Revised Geotechnical Investigation Report

Altman Residence

63 Tamalpais Road

Subject: ALTMAN- Task List for Resubmittal to Fairfax Planning 9-30-22

Sheet Title:
CONSTRUCTION STAGING PLAN
 Scale: AS NOTED
 Sheet No. **A2.0.4**

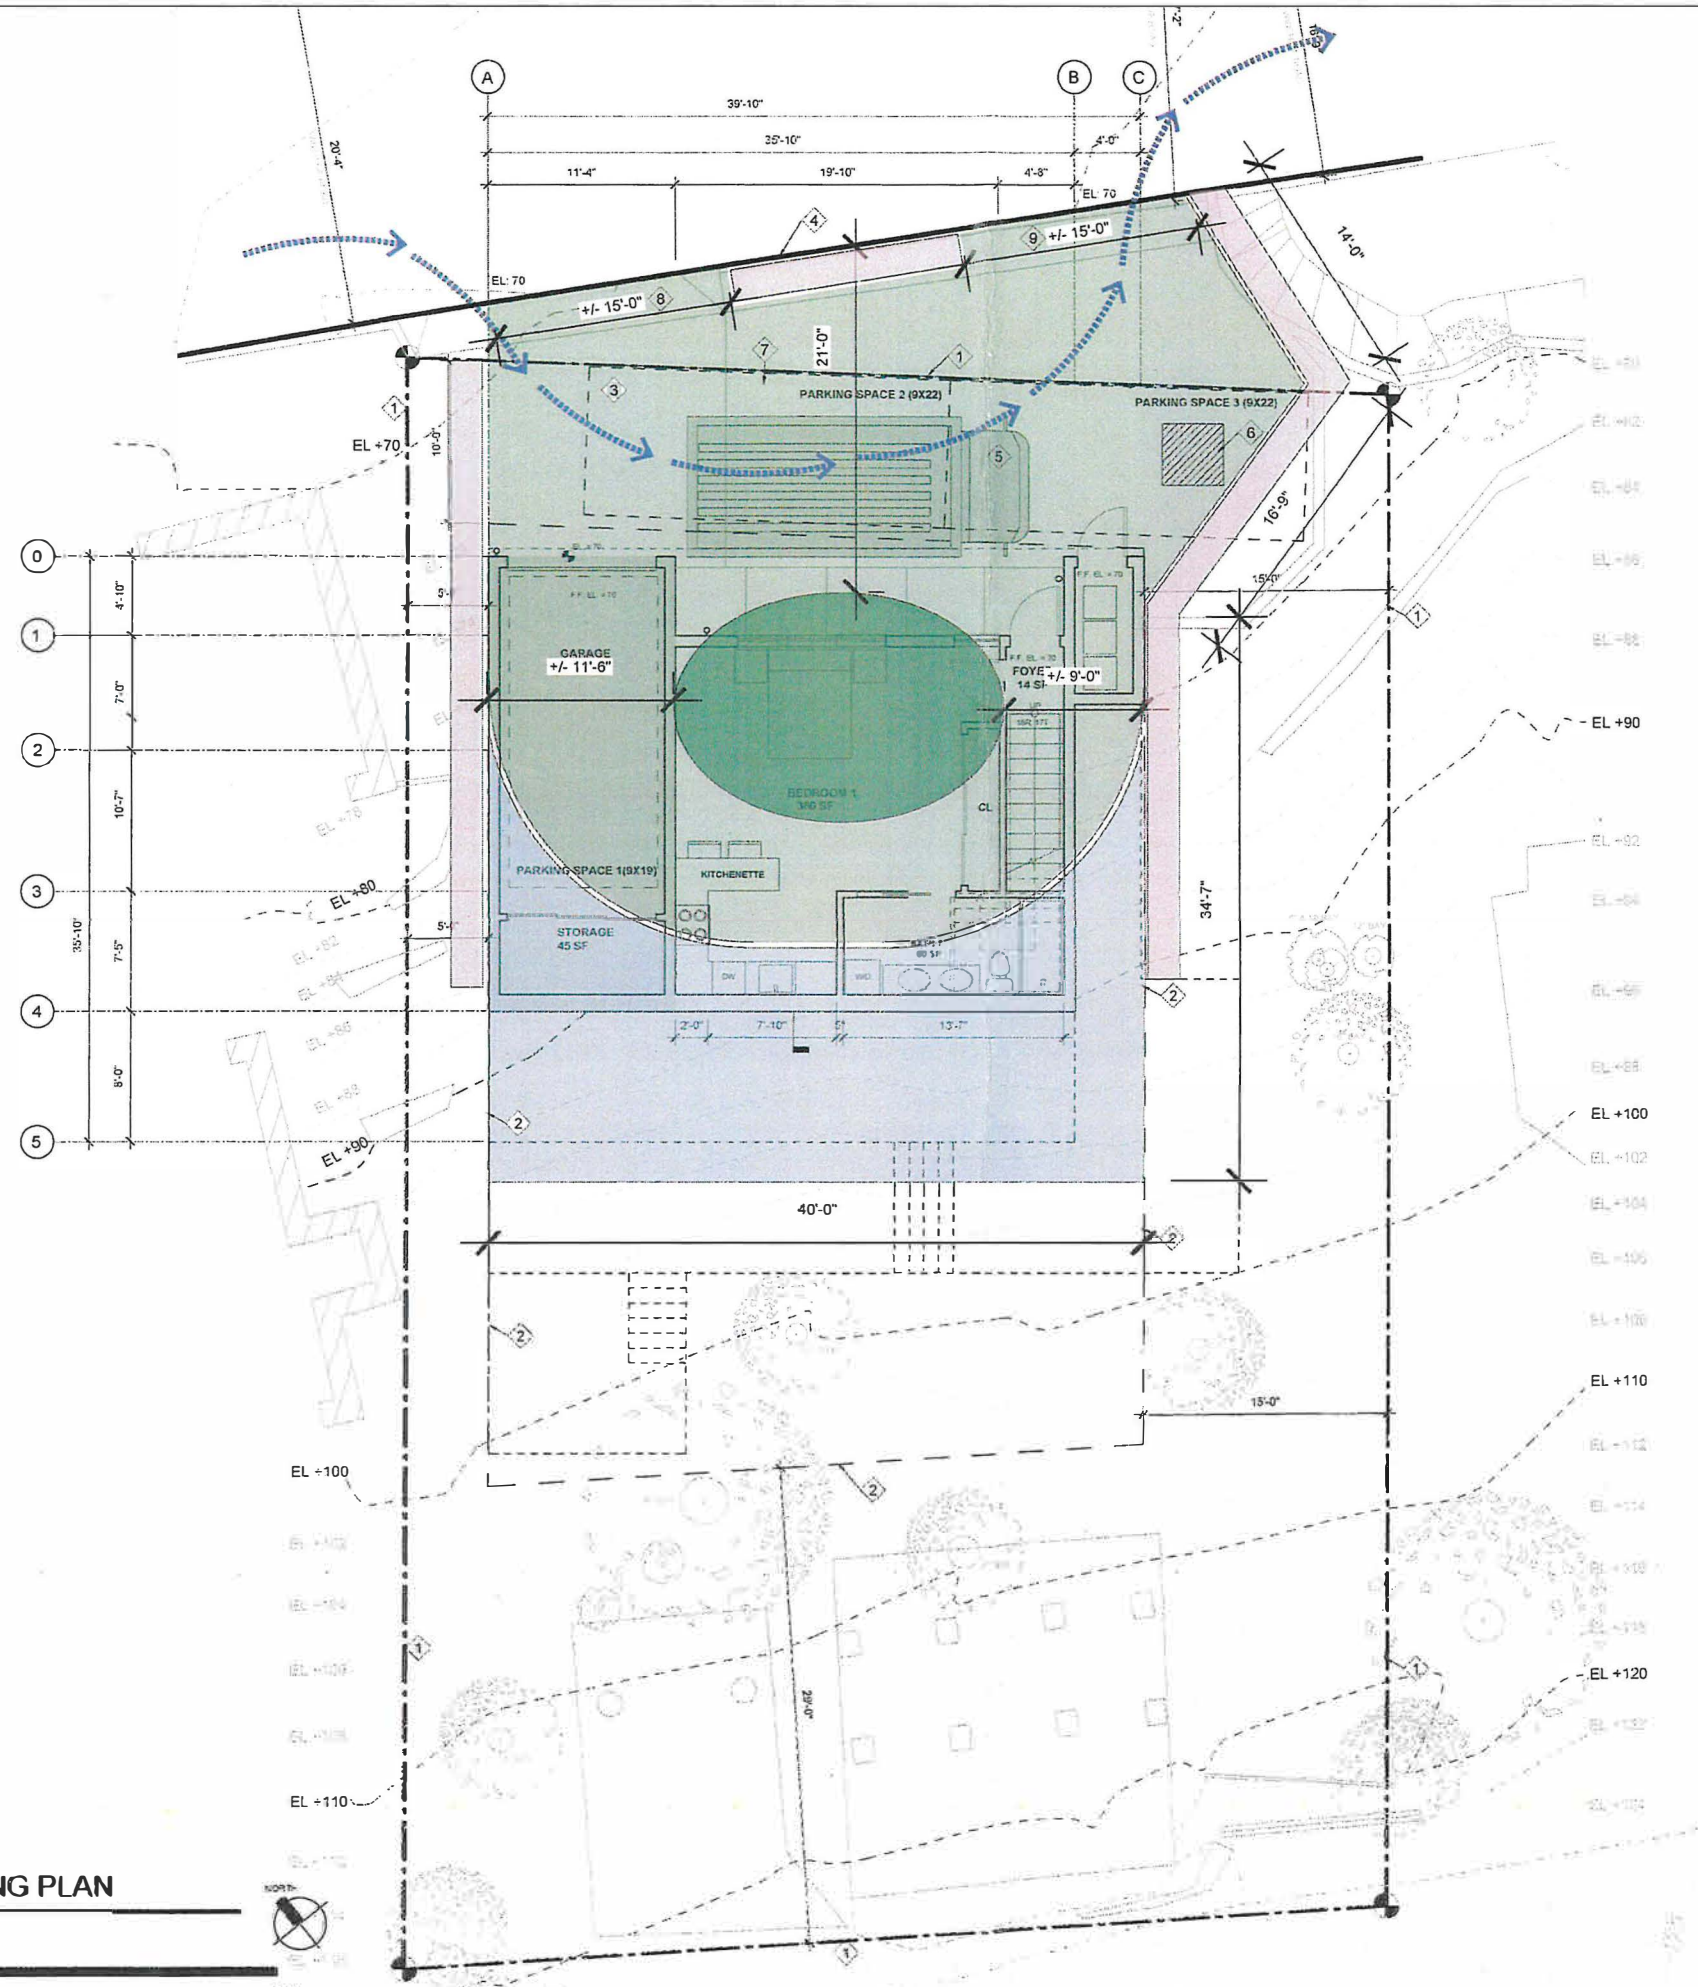
Requiring a detailed construction management plan- this is usually done by the contractor but Kappe Architects will develop such a plan. They state that this is because structural drawings are not yet provided. They estimate that the off-haul will be more than 850 cubic yards. We did factor in for foundations already
